Office Action Summary

09/739,975

FUKUSHIMA ET AL.

DETAILED ACTION

FIG. 1

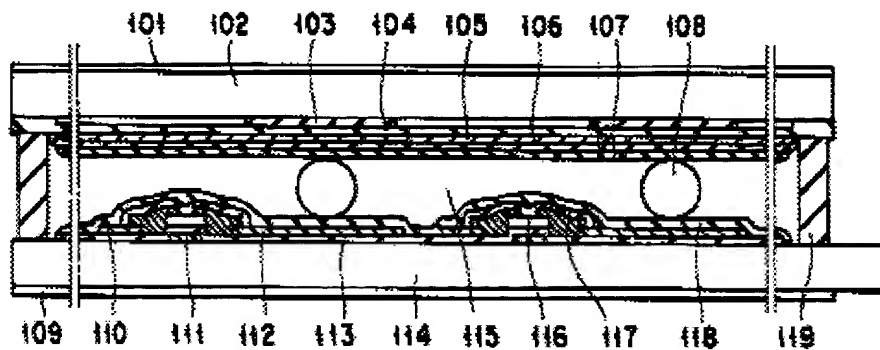
As to claim 8, Saishu discloses in Figure 1 (col. 6, line 60 through col. 8, line 45), a liquid crystal display element comprising: a first substrate, 114; a switching element disposed on said first substrate; a second substrate, 102, counter to said first substrate; a first alignment layer formed over said switching element, 118; a second alignment layer, 107, formed over said second substrate, wherein said first and second alignment layers are rubbed in rubbing directions (col. 7, lines 35-40); a light modulating layer, 115, disposed between said first and second substrates wherein the light modulating layer comprises an anti-ferroelectric liquid crystal material having a thresholdless voltage-transmittance characteristic (col. 7, lines 43-45); and a filter, 104, formed on said second substrate, wherein said filter allows specific wavelengths of light to pass.

Saishu does not explicitly disclose an element wherein the surface tension of each of said first and second alignment layers is between about 49 dyn/cm and about 53 dyn/cm.
